UNITED STATES PATENT AND TRADEMARK OFFICE

APPLICATION NO.	FILING DATE	FIRST NAMED INVENTOR	ATTORNEY DOCKET NO.	CONFIRMATION NO.
10/814,610	03/30/2004	Darin G. Schaeffer	8627-190	5422

Office Action Summary

DETAILED ACTION

Attachment #1 (marked up)

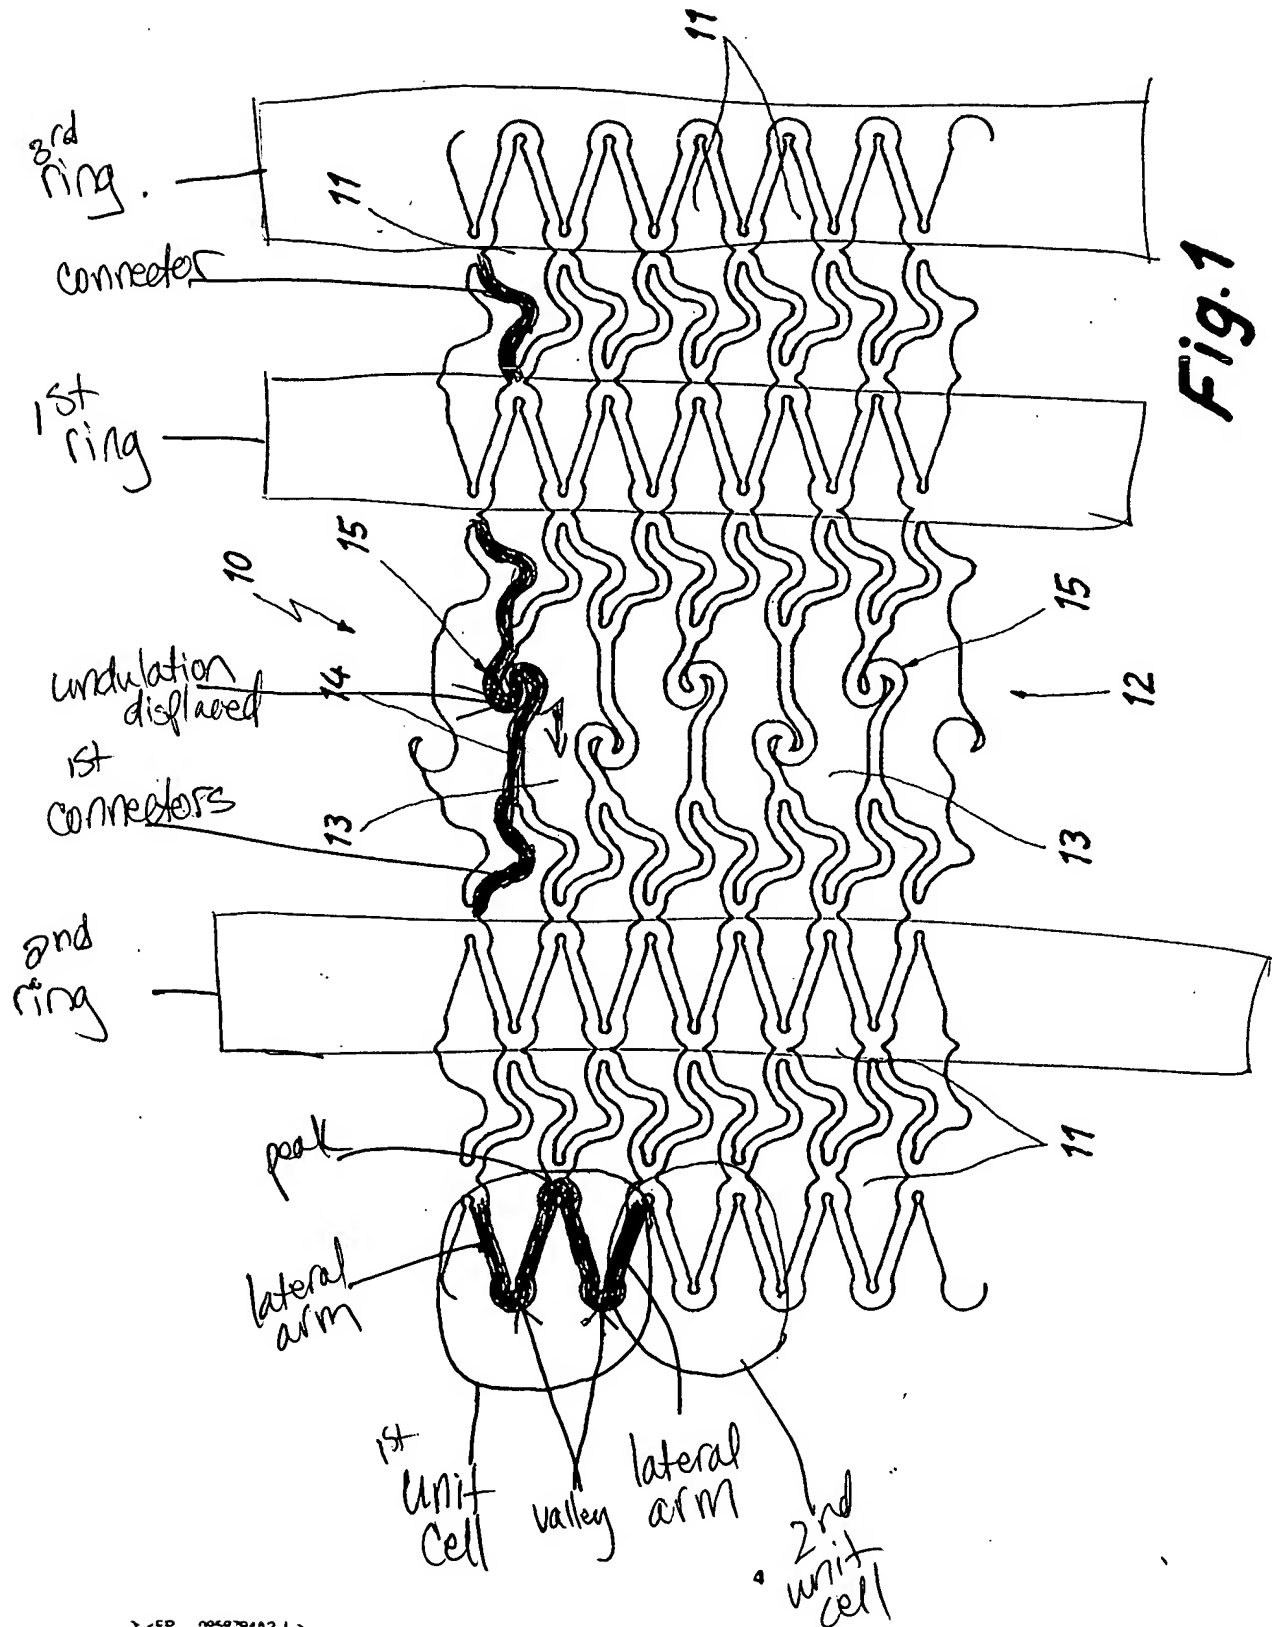
Claims 1-8 and 11-22 are rejected under 35 U.S.C. 102(b) as being anticipated by Schmitz et al. (EP 0 958 794 A2, cited in IDS). Referring to claims 1 and 17 groupings, Schmitz discloses a stent (10) having first, second, and third ring structures, a first plurality of connector segments joining the first and second ring structures and a second plurality of connector segments joining the first and third ring structures, wherein the undulation of the first connectors are axially displaced from one another and the undulation of the second connectors are axially aligned to one another. Schmitz discloses the ring structures to comprise units, each unit having two lateral arms and a central region having a peak and two valleys. Schmitz discloses the undulating connector to form u-shaped bends. Schmitz discloses pads having an enlarged and narrow throat region. See attachment 1, figure 1, where claimed structures are pointed out.

Attachment #2 (markedup)

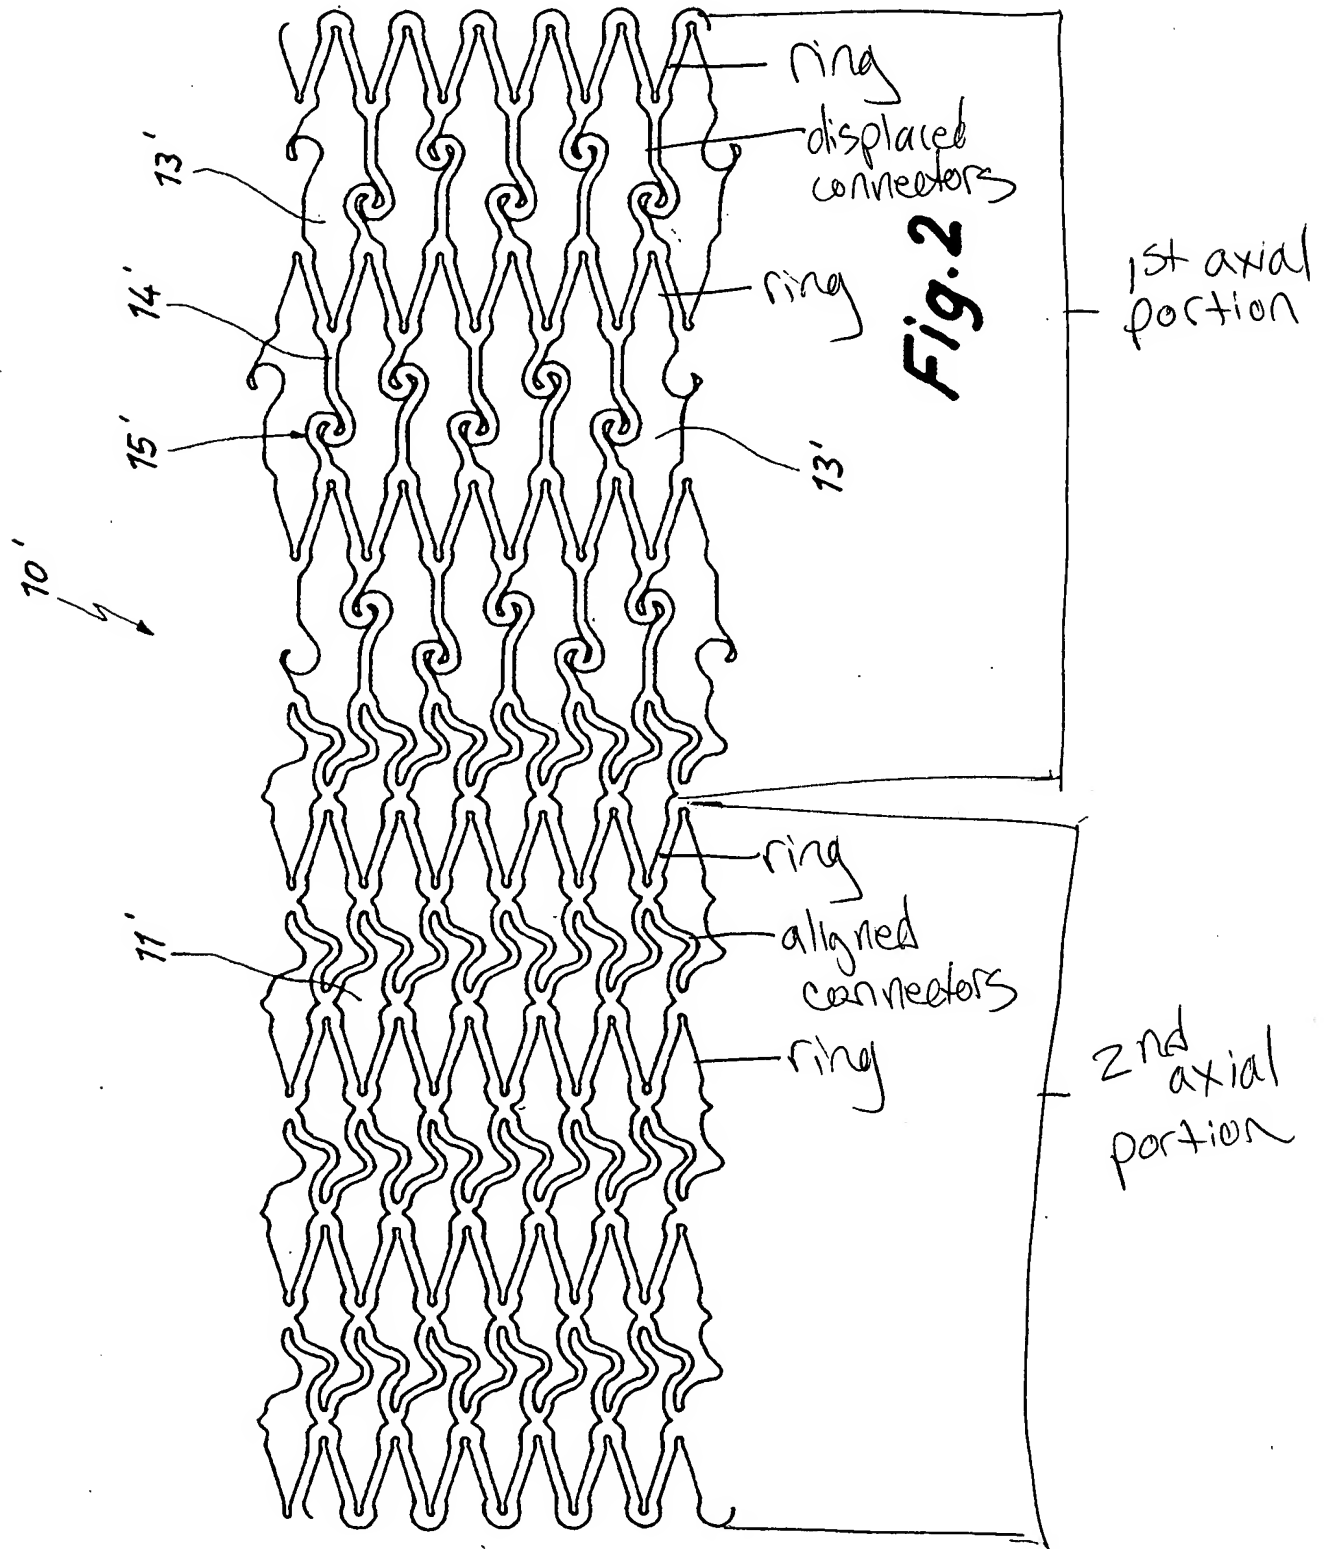
Referring to the claim 11 grouping, Schmitz discloses a stent comprising first and second axial portions, the first axial portion having a plurality of ring structures joined by axially displaced connectors and the second axial portion having another plurality of ring structures joined by axially aligned connectors. See figure 2, attachment 2.

Attachment #3 (marked up)

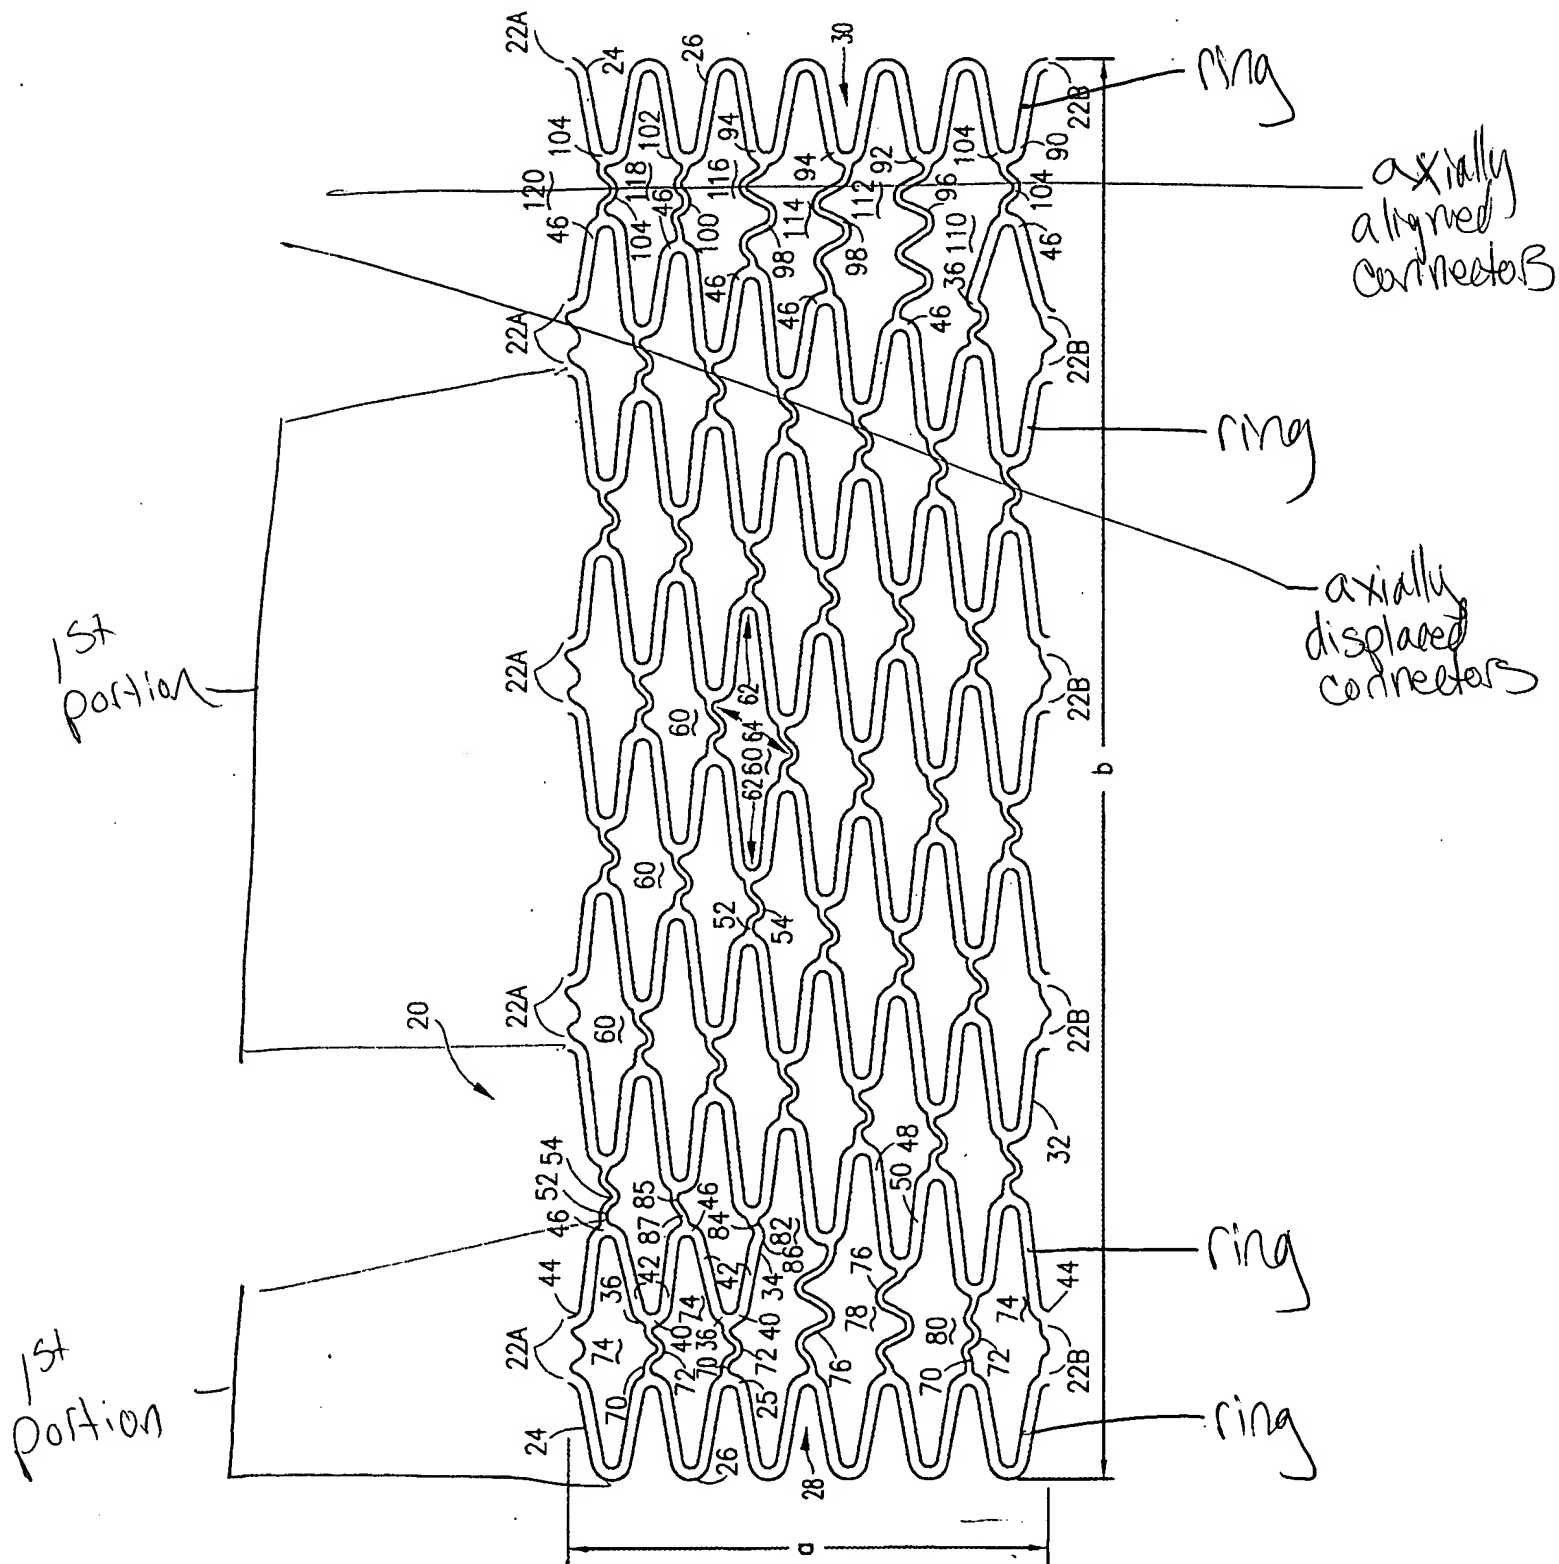
Claims 11-22 are rejected under 35 U.S.C. 102(e) as being anticipated by Levinson et al. (US 6,352,552 B1). Referring to the claim 17 grouping, Levinson discloses a stent having a plurality of ring structures (24, 32) joined by a plurality of connector segments (52, 70, 96, 98, 100), each of the connector segments having an undulating portion (bend 54, 76, 72, etc), wherein a first circumferential set of connector segments are axially aligned and a second circumferential set of connector segments are axially displaced. See attachment 3.

Referring to the claim 11 grouping, Levinson discloses a stent comprising first and second axial portions, the first axial portion having a plurality of ring structures joined by axially displaced connectors and the second axial portion having another plurality of ring structures joined by axially aligned connectors. See figure 1, attachment 3.
